FOUNDATION PERMIT

RE: TB-20-785 Almy St. (S.S.) 240' W. x Acushnet Ave. Plot 134 Lot 123 Reviewed 10/7/2020

RE: TB-20-785 Almy St. (S.S.) 240' W. x Acushnet Ave. Plot 134 Lot 123 Reviewed 5/15/2020

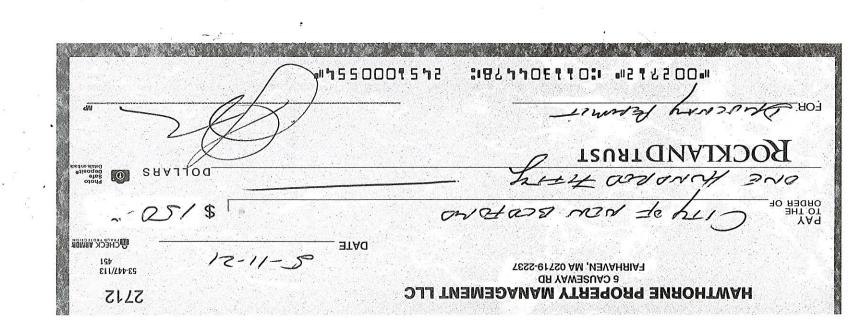
The site plan submitted via view permit for the above location was reviewed and found to lack the information required for DPI to conduct a proper review of the site. A revised site plan must be submitted for review and all proposed work must meet DPI requirements and construction specifications/standards. Copies are available through the DPI office.

- 1. Please check that all existing site conditions are shown (i.e. abutting right-of-ways, driveways/sidewalks, curb/berm or edge of pavement, buildings, utilities, mains/service connections, shut offs, clean outs, septic system (if any), easements, grading, etc.). Make sure everything is properly called out/labeled (i.e. size/type of existing mains, services, type of curb/berm, etc.).

- 2. Show all proposed work (i.e. new structure(s), water/sewer/storm drain mains/service connections or septic system, driveway(s)-new/closure/widening, storm recharge system for roof runoff (to include calculations), details and grading, etc.). Make sure everything is properly called out/labeled (i.e. proposed 1" copper water service, proposed 18' wide asphalt driveway apron, etc.).

- 3. Based on the recorded ANR submitted in View Permit and the property information on file for this location, the building that is to be razed is not a dwelling, it is an accessory building (garage). The footprint is also larger on the site plan, but it appears it's due to the open porch that extends out the back side of the garage. Please update accordingly.

- 4. Check that the site plan being submitted has been stamped/signed by the proper professional(s) responsible for the site development and design (i.e. Professional Engineer and/or Land Surveyor, depending on the case). This plan must also be stamped by the Engineer who designed the infiltration system and the proposed utility connections.

- 5. Check with DPI to obtain the record information for the existing water/sewer within the ROW and update accordingly. Please make sure to inquire whether there was a sewer betterment and if a sewer service stub was left at the property line at the request of the owner for possible future development. Please check the required distances for placement of the water curb stop and sewer cleanout. Please update accordingly.

- 6. Please note that being that the garage shown on Lot 125 of the ANR plan is going to be razed, the subject lot (shown as Lot 1 on the ANR) will be assigned a parcel id of Map 134, Lot 123. Please update accordingly. The Lot 2 will be assigned Map 134, Lot 126, which is what it is already being called out as on the site plan submitted.
